# Access Compliance Report

## Public Rights-of-Way

Intersection ID: 43365	Main Street: EASTFIELD_RD	Cross Street: SIMONTON_DR	Location: S
ADA ID: DBCE081DCAB9	Ramp Type: Perp	Initial Pass/Fail: Fail	Overall Compliance: No
			Severity Score: 13.75

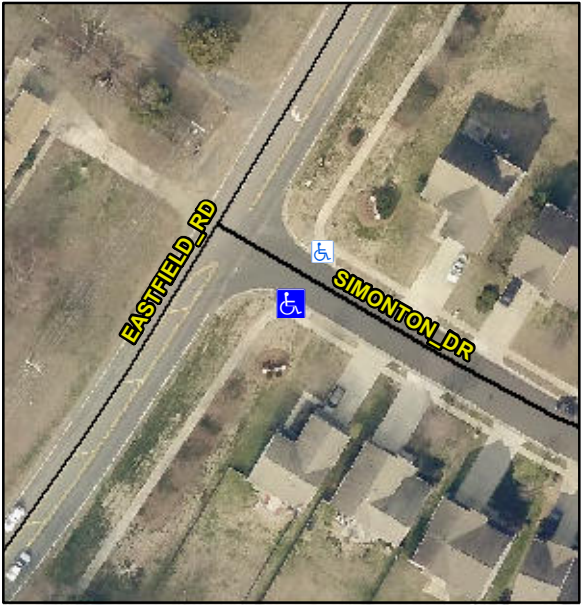
Codes/Mitigation Info/Possible Solution			Field Measurements/Component Compliance		
	Possible Solutions:		<b>Compliance</b>	<b>Description</b>	<b>Data</b>
	<b>Remove &amp; Replace Entire Ramp.</b>		<b>No</b>	Ramp Length (in)	<b>50.0</b>
			<b>Yes</b>	Ramp Width (in)	<b>48.0</b>
			<b>N/A</b>	Flare Type LT	<b>N/A</b>
			<b>N/A</b>	Flare Slope LT (%)	<b>N/A</b>
			<b>N/A</b>	Flare Traversable LT?	<b>N/A</b>
			<b>N/A</b>	Landing Length (in)	<b>N/A</b>
			<b>N/A</b>	Landing Width (in)	<b>N/A</b>
			<b>N/A</b>	Landing Slope (%)	<b>N/A</b>
			<b>N/A</b>	Landing X Slope (%)	<b>N/A</b>
<p>Surveyor Notes:</p> <p><b>N/A</b></p> <p>PROW/ADA:</p> <p><b>Not Found, R304.2.2, R304.5.3</b></p>			<b>N/A</b>	Flare Type RT	<b>N/A</b>
			<b>N/A</b>	Flare Slope RT (%)	<b>N/A</b>
			<b>N/A</b>	Flare Traversable RT?	<b>N/A</b>
			<b>N/A</b>	DWS Provided?	<b>N/A</b>
			<b>N/A</b>	DWS Contrast?	<b>N/A</b>
			<b>N/A</b>	DWS Length (in)	<b>N/A</b>

<b>N/A</b>	DWS Full Width?	<b>N/A</b>
			<b>N/A</b>	DWS Offset (in)	<b>N/A</b>
			<b>N/A</b>	Gutter Ponding?	<b>N/A</b>
			<b>N/A</b>	Gutter Lip Ht (in)	<b>N/A</b>
			<b>No</b>	Painted X Walk1?	<b>N/A</b>
			<b>To NE</b>	X Walk 2 Direction	<b>N/A</b>
			<b>N/A</b>	X Walk 2 Width (in)	<b>N/A</b>
			<b>4.8</b>	X Walk 2 Slope (%)	<b>N/A</b>
			<b>3.8</b>	X Walk 2 X Slope (%)	<b>N/A</b>
			<b>N/A</b>	Ramp inside XWalk1?	<b>N/A</b>
			<b>N/A</b>	Ramp inside XWalk2?	<b>N/A</b>
			<b>N/A</b>	Clear Space?	<b>N/A</b>
			<b>N/A</b>	Clear Space to XWalk (in)	<b>N/A</b>
			<b>N/A</b>	Storm Grate/Utility Hazard?	<b>N/A</b>
			<b>N/A</b>	Obstruction Type	<b>N/A</b>
			<b>N/A</b>	Storm Grate/Utility Type	<b>N/A</b>
Total Cost:			<b>\$ 1850.00</b>		
				<b>Yes</b>	Surface Condition? (G/P) <b>Good</b>
